RE: **ISOLATED PHOTODIODE**

Application No.: 10/044,974

REQUEST FOR APPROVAL OF DRAWING CORRECTIONS

FIG. 1

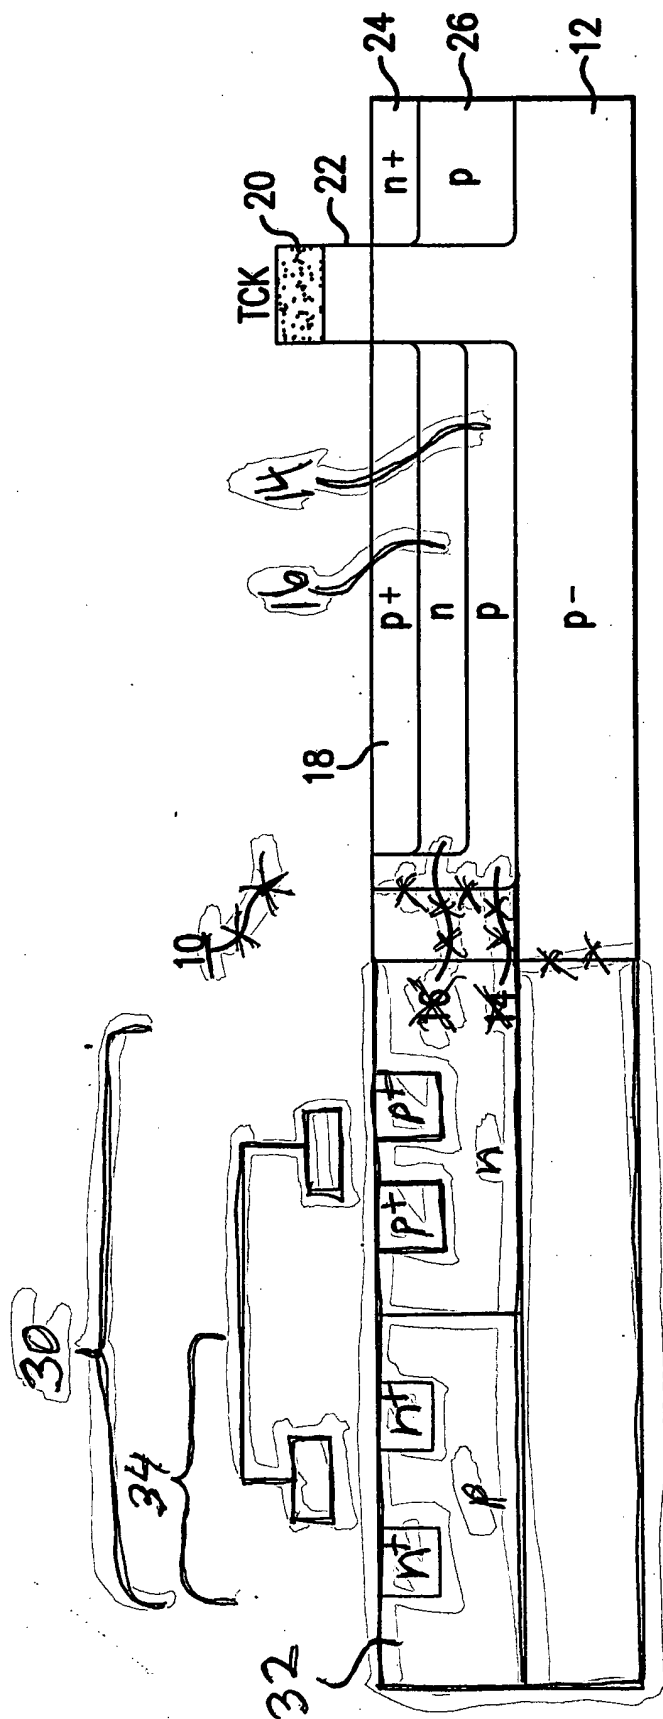
The corrections to FIGS. 1-3 correct original FIGS. 1-3 to conform the drawings to the specification. The specification, on pages 4 and 5 disclose: (1) sensor 10 as including CMOS circuitry (illustrated as circuitry 30), (2) sensor 40 as including CMOS circuitry (illustrated as circuitry 60), and (3) sensor 70 as including CMOS circuitry (illustrated as circuitry 90). Furthermore and referring to FIGS. 1-3, page 8, lines 8-15 of the specification discloses that at least one n-FET (illustrated as 34) are formed in a p well (illustrated as 32). The depiction of CMOS circuitry in proposed FIGS. 1-3 includes no more subject matter than what would be understood by a person of ordinary skill in the art from the disclosure of CMOS circuitry described on pages 4, 5 and 8. No new matter was added to the proposed corrections to FIGS. 1-3.

FIG. 7

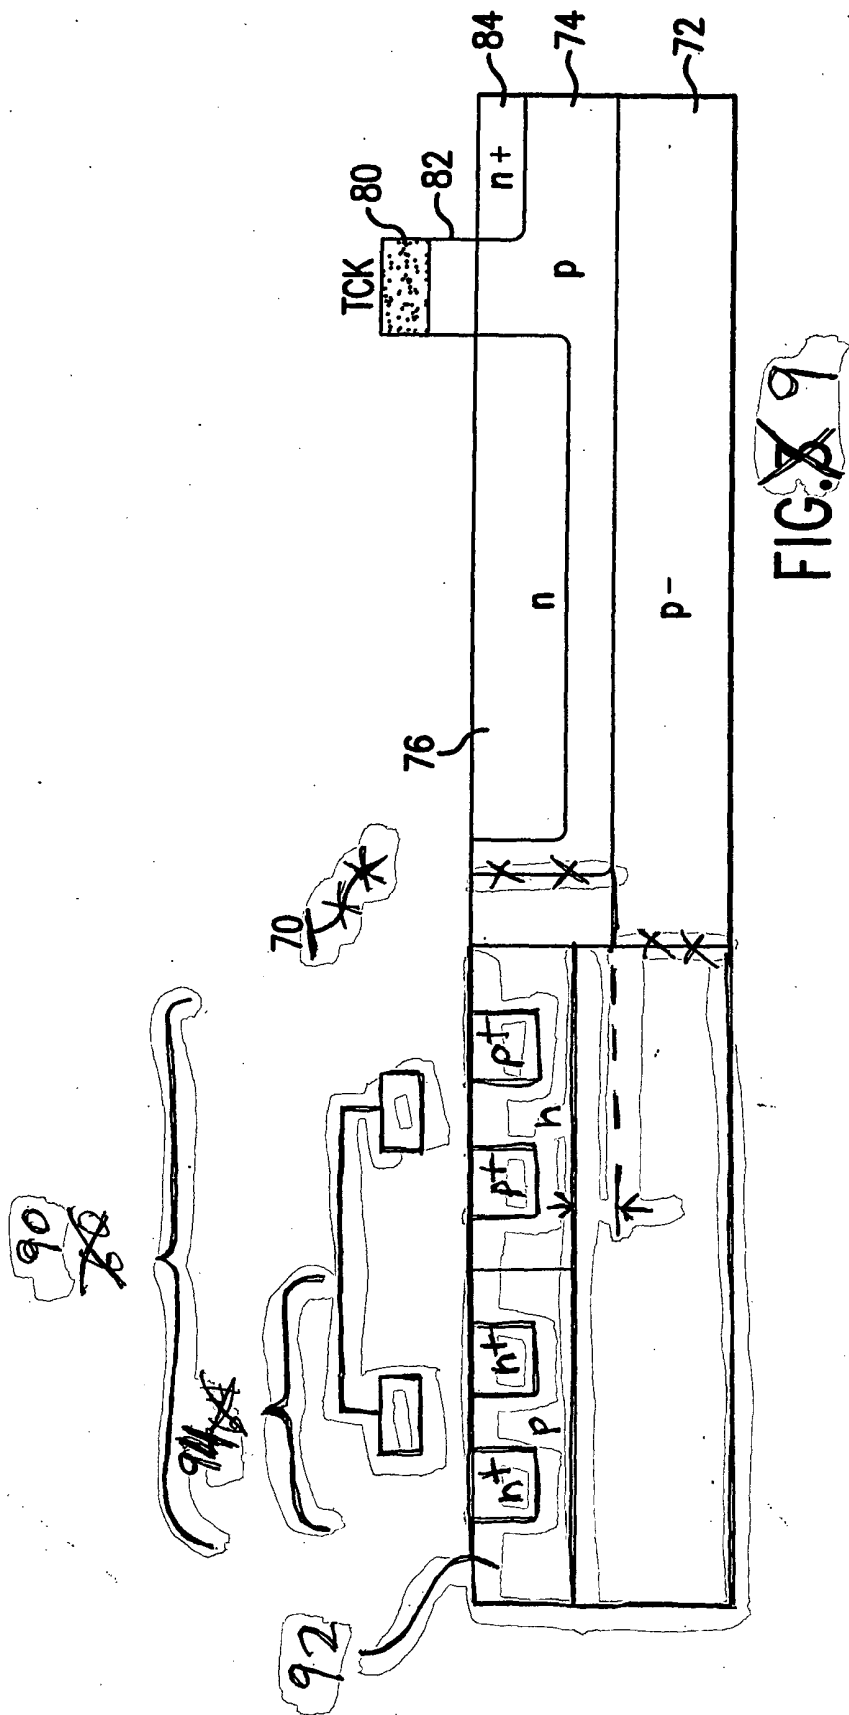
The additional FIGS. 7-9 are proposed to further conform the drawings, as a set, to the specification, as a whole. FIGS. 7-9 derive from the original disclosure of corrected FIGS. 1-3 and the original disclosure in the specification on page 8, lines 16-19 where the p implant

beneath the photodiode is increased in depth by an extra implant process beyond the conventional CMOS p well implant process. No new matter was added in the proposed additional FIGS. 7-9.

FIG. * 10

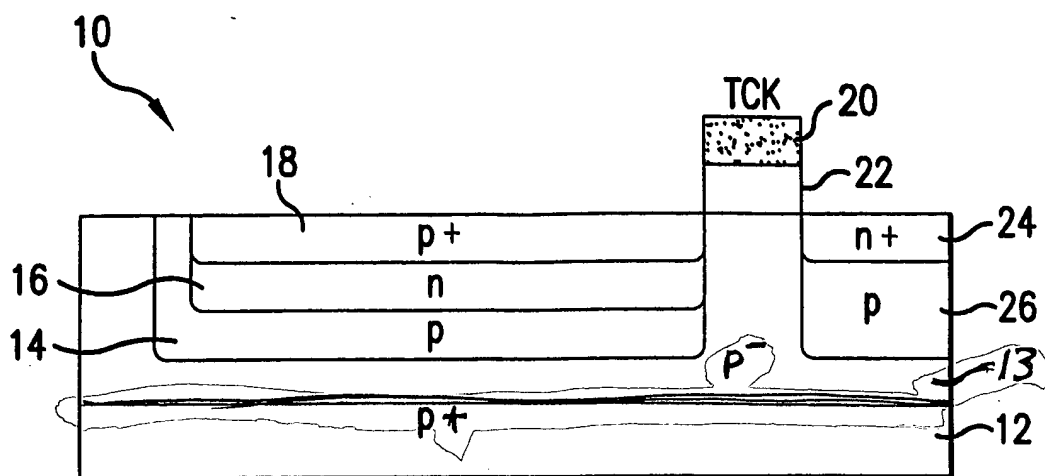
The additional FIGS. 10-12 are proposed to further conform the drawings, as a set, to the specification, as a whole. FIGS. 10-12 derive from the original FIGS. 1-3 and the original disclosure in the specification on page 9, lines 5-15. No new matter was added in the proposed additional FIGS. 10-12.
